TECHNICAL NOTE

Project Title: Land South of Grevatts Lane/ A259

Report Reference: JNY10830-07

APPLICATION REF: M/16/22/PL – WSCC HIGHWAY AUTHORITY COMMENTS

Status	Drawn By	FM/Checked by
PRELIMINARY	AJ	MA
Project Number	Scale @ A3	Date Created
JNY10830	1:200 /1:500	10/11/21
RPS Drawing/Figure Number		Rev
JNY10830-09		F
rpsgroup.com

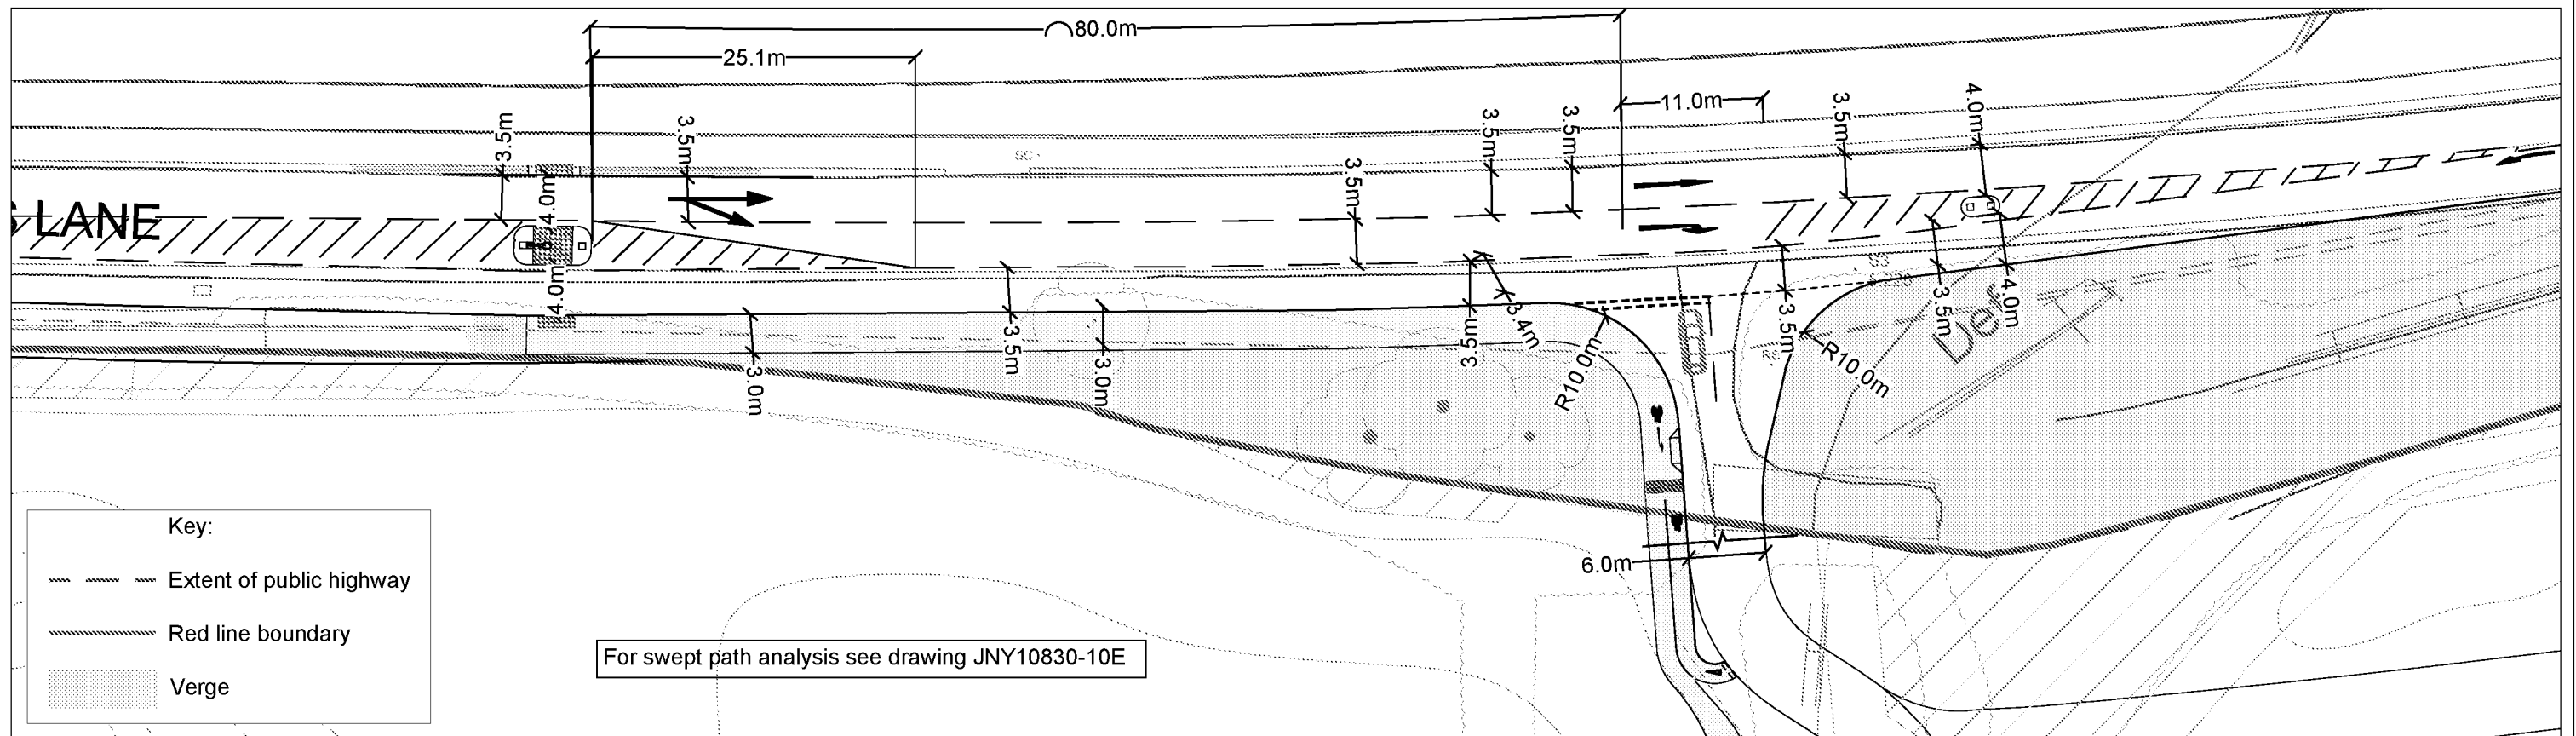
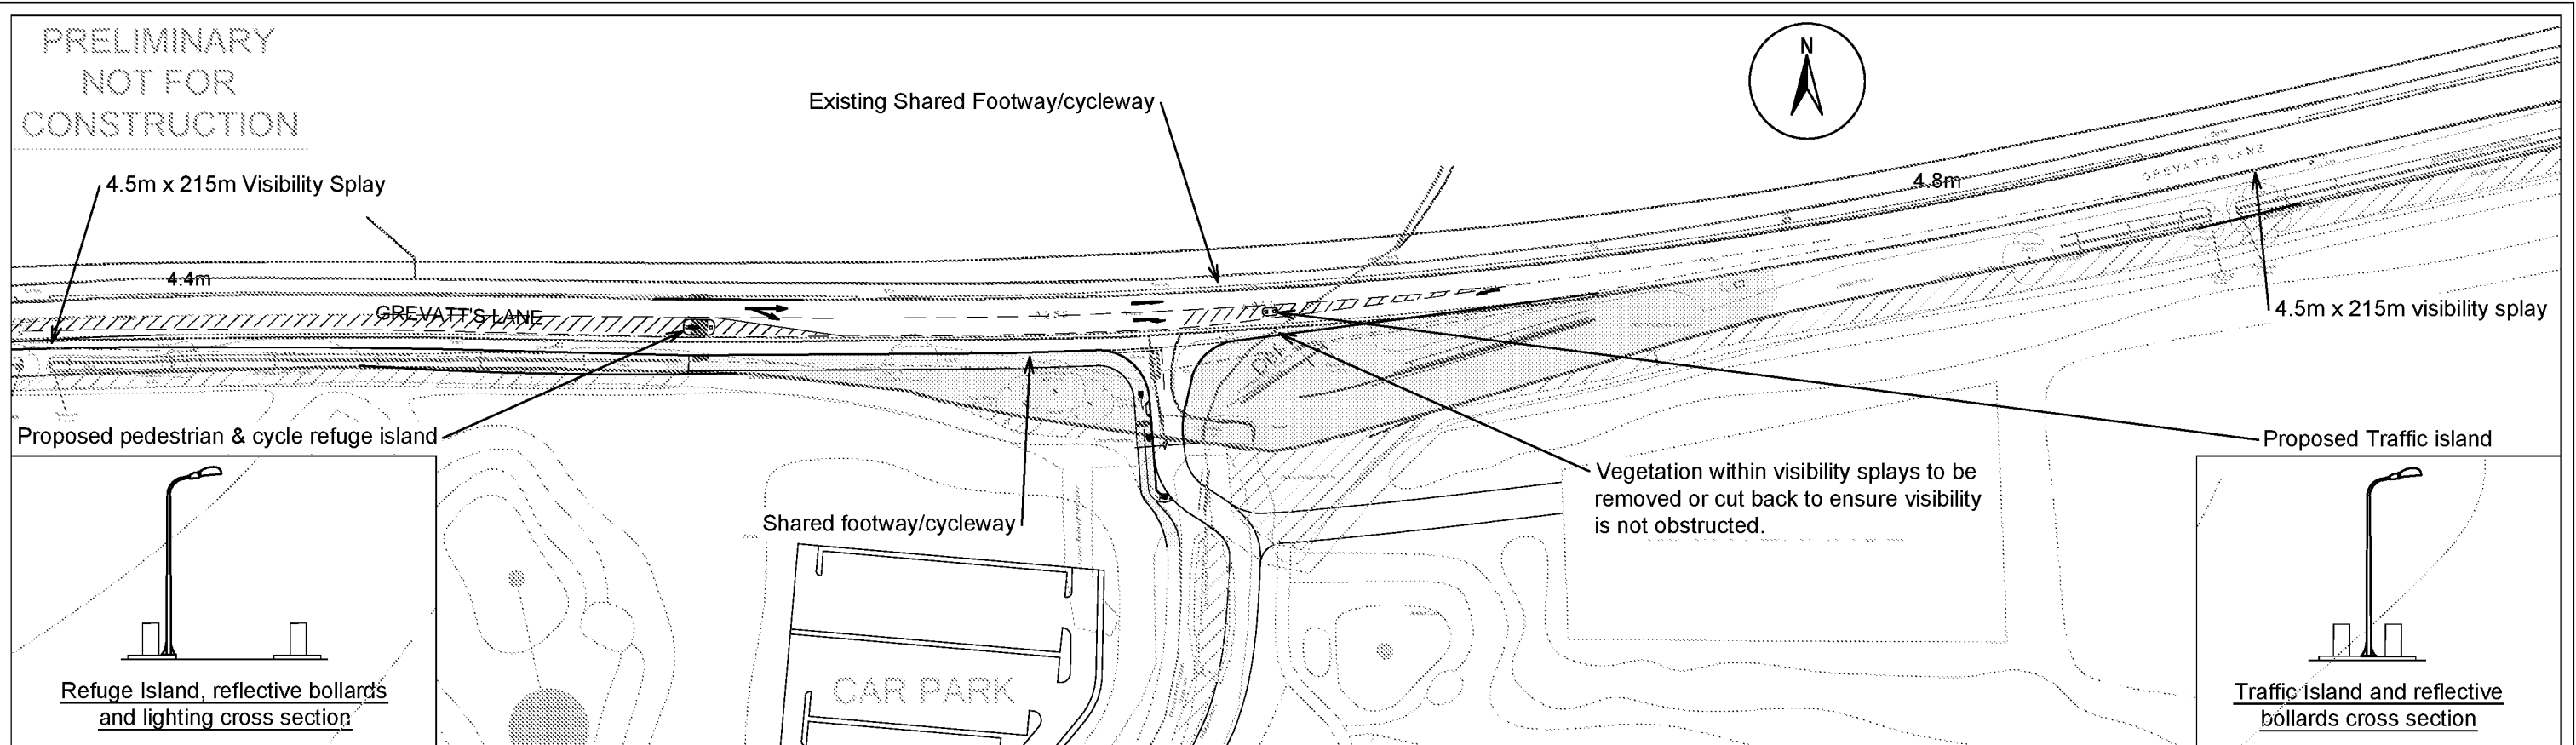
- 1.4 *Although reference is made to the design of the turning lane and access being compliant with Design Manual for Roads and Bridges (DMRB), no formal design check appears to have been submitted. As such, the applicant should provide one for the CHA to consider, including identification of any Departures from Standard (DFS). Additionally, a revised plan should be submitted with dimensions added including kerb-to-kerb widths of running lanes either-side of the proposed refuge island. Lighting may need to be considered for the junction arrangements*
- 1.5 The drawing included in Appendix A of the TA includes details of the road widths, radii etc., the DMRB standards for a ghost island right turn lane are provided in CD123 Geometric Design of at-grade priority and signal controlled junctions.

- 1.6 The width of the right turn lane has been increased to 3.5m following feedback from WSCC Technical Team and the width between kerbs at the traffic island/pedestrian refuge is 4m.

- 1.7 The proposed pedestrian refuge is 3.5m in depth to allow for both pedestrians and cyclists, Table E/4.7 in CD 143 advises that the desirable minimum depth for shared use is 3.0m.

- 1.8 CD143 also advises in Para E/4.6 '*Refuge Island shall not be provided where the speed limit is greater than 40mph except where the refuge island is incorporated into a single lane dualling design.*' The proposed refuge islands are therefore a departure from Standard and the DoS form has been completed for this and included in **Appendix 1**.

- 1.9 The above dimensions are shown on drawing No. JNY10830/09F included in **Appendix 1**.
- 1.10 It is acknowledged that lighting may be required although this can be a condition of planning if considered necessary. Lighting is presently shown for the proposed traffic islands.

- 1.11 Following further discussions with WSCC, a review of the existing accesses serving the adjacent fields was requested to ensure the proposals did not affect the ability for farm vehicles to manoeuvre into and out of the fields. The review shows that there is one field access close to the proposals, this is situated some 220m west of the proposed access arrangement and is shown on Drawing No. JNY10830/18A. The proposals will actually improve the ability for farm vehicles to turn in as the road will be widened in this location together with centre line hatching to join the access serving the proposed access arrangement that will serve the new Crematorium.

- 1.1 The proposed arrangement takes on board the comments raised by the Road Safety Auditor as well as including the extent of works proposed as part of the Crematorium access proposals to the west of the site. The layout including the Crematorium access is included in **Appendix 1**.

F	Adjustments made to reflect WSCC comments	MA/AJ	MA	11:05:2
E	Adjustments made to tie into Crematorium access arrangement & address RSA Comments	MA	MA	22.04.2
D	Additional Dimensions Added	MA	MA	23.03.2
C	Footway Width Amended	MA	MA	26.01.2
B	Topo survey added	AJ	MA	16.12.2
A	Following RSA comments	AJ	MA	25.11.2
Rev	Description	By	CB	Date

RPS Drawing/Figure Number	Rev
JNY10830-10	E

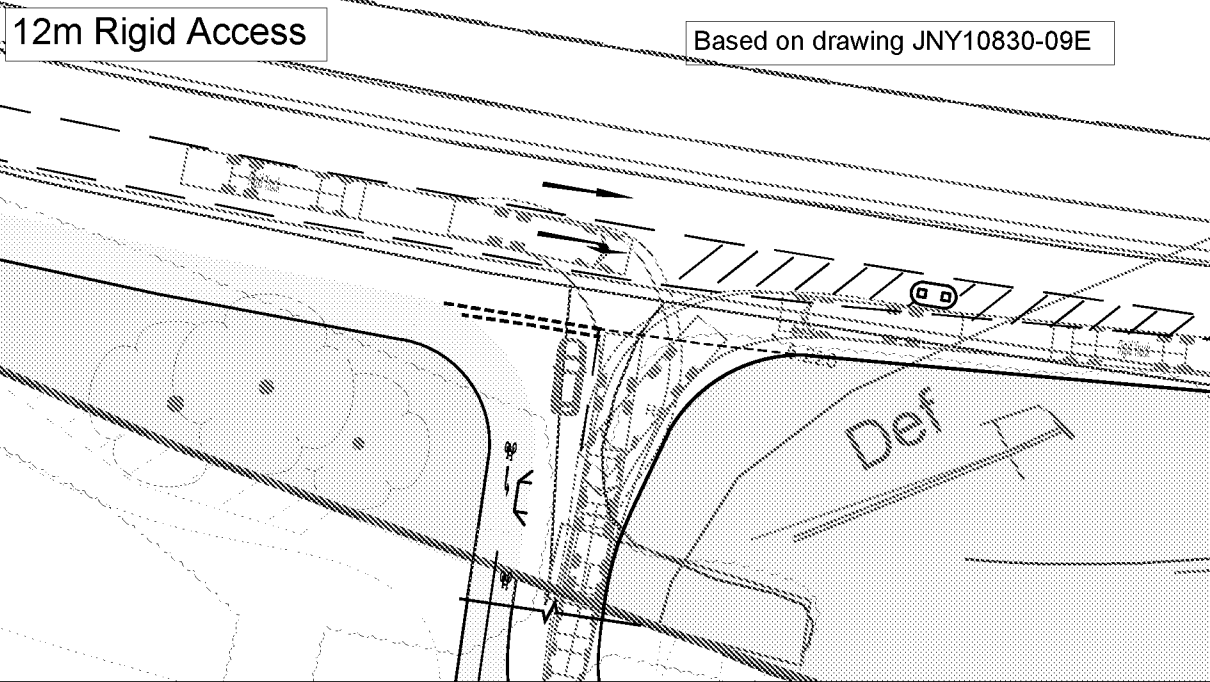
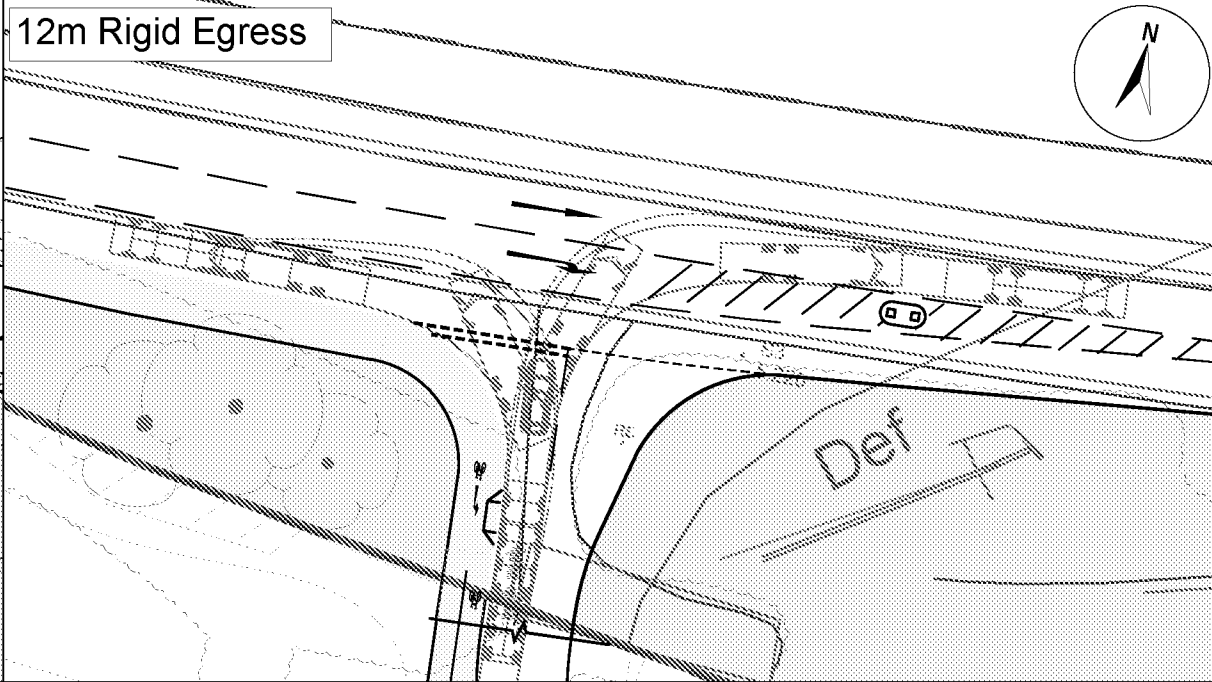
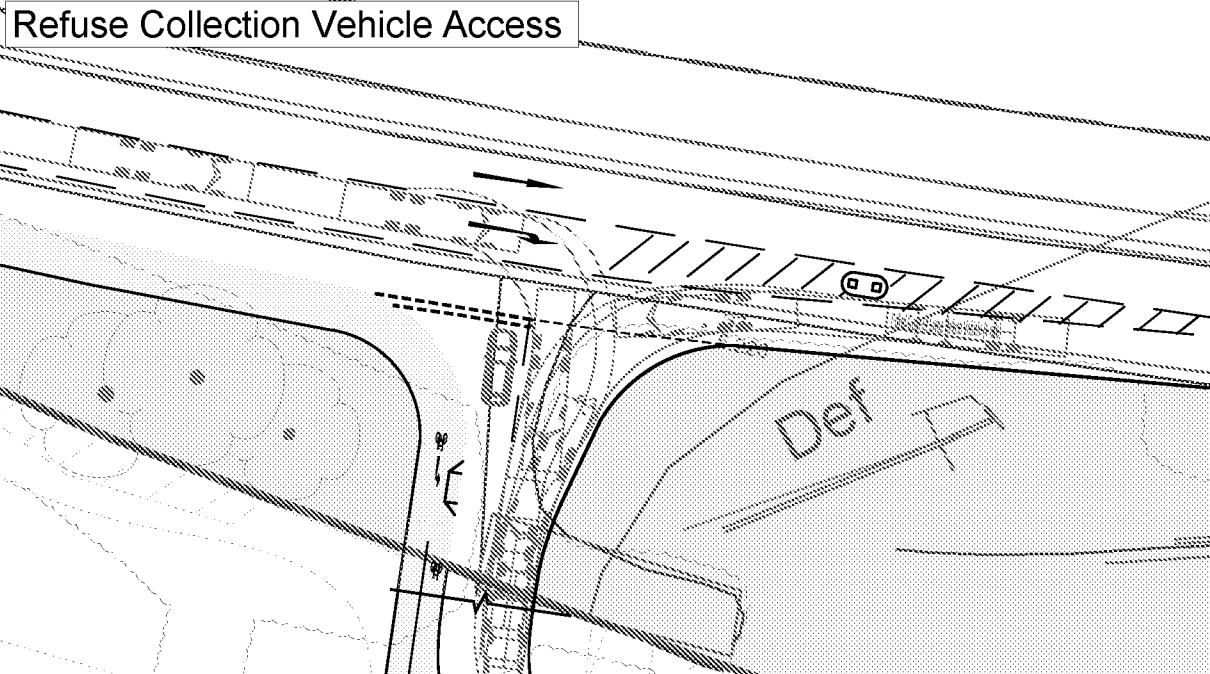
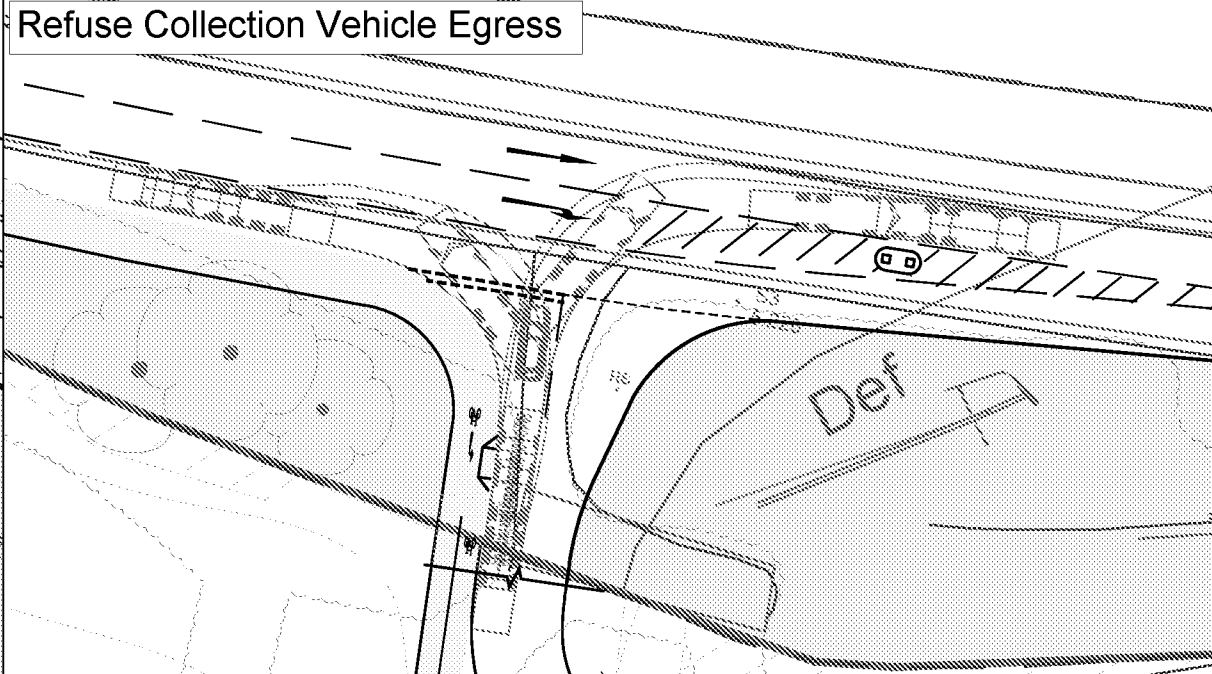
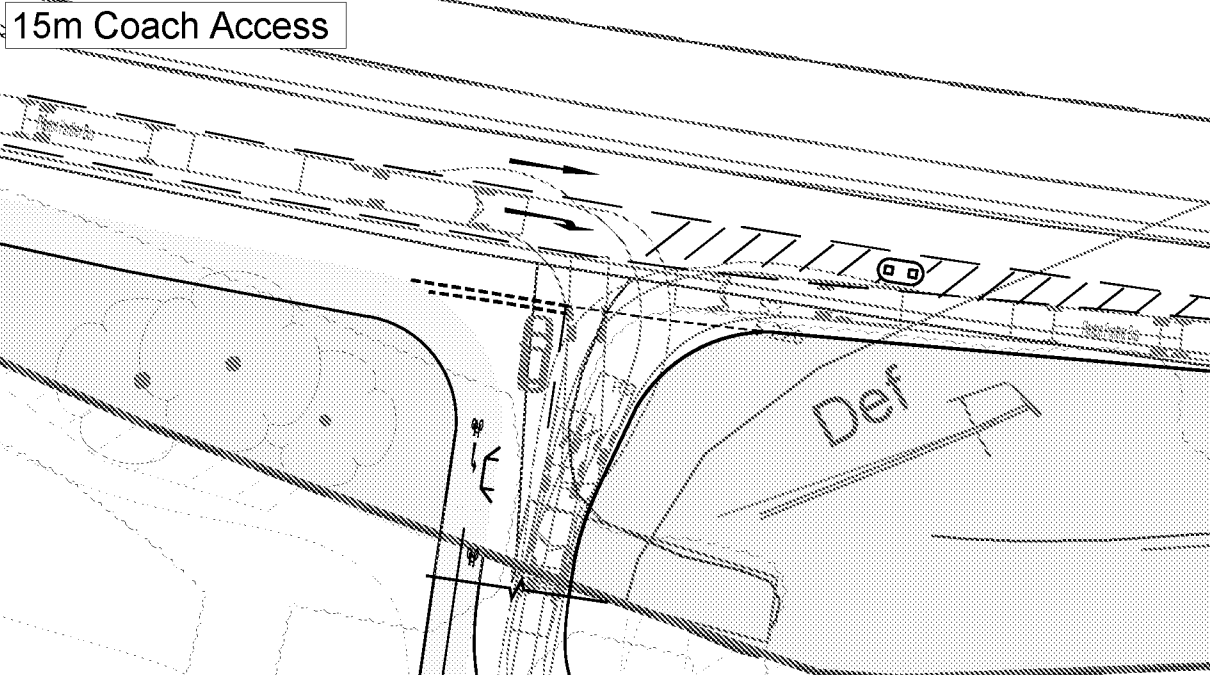
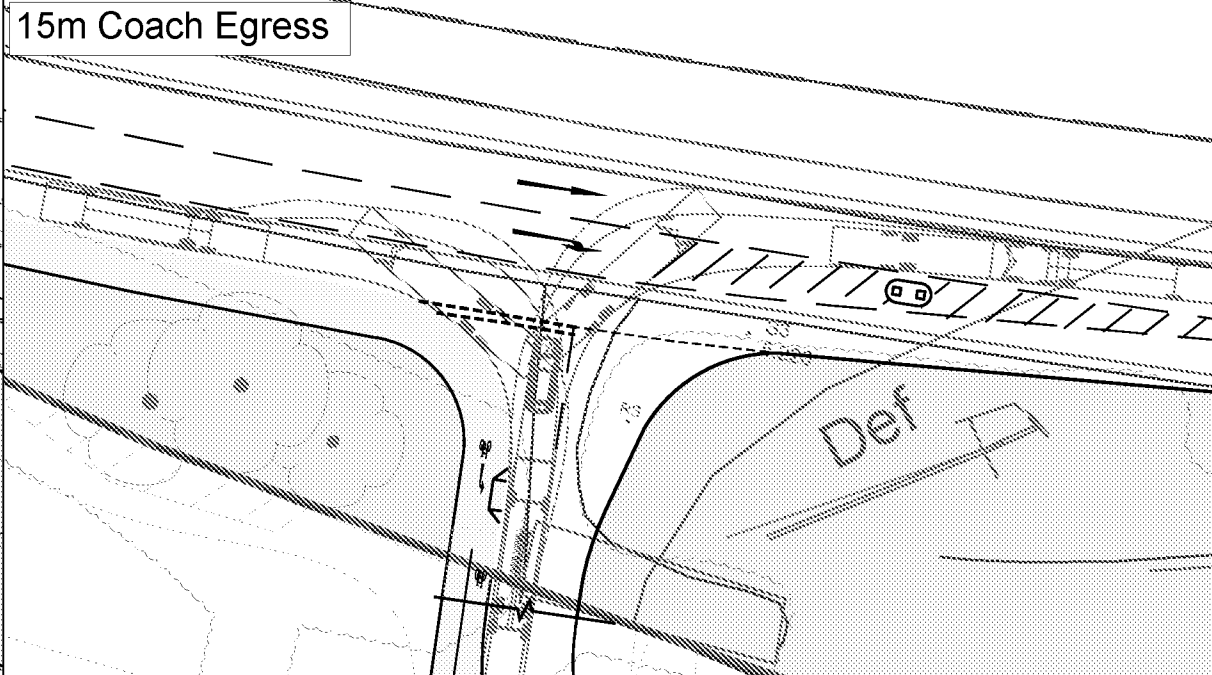
- 1.28 *Bus and coach parking (and waste and serving requirements) - None has been shown. Applicant to provide details of such uses/requirements and plans showing access, parking and turning arrangements for such vehicles.*
- 1.29 The Club has advised that the site is expected to not have more than one coach accessing the site at any one time and that this would be a very infrequent occurrence, possibly once a month. The proposal includes a lay-by within the maintenance area for the coach to wait. The tracking of a coach is included in **Appendix 5**.

E	Tracks adjusted to suite Drawing JNY10830-09F	AJ	MA	11.05.22
D	Layout adjusted to suite Drawing JNY10830-09E		MA	22.04.22
C	Footway Width amended		MA	26.01.22
B	Topo survey added	AJ	MA	16.12.21
A	Following RSA comments	AJ	MA	25.11.21
Rev	Description	By	CB	Date
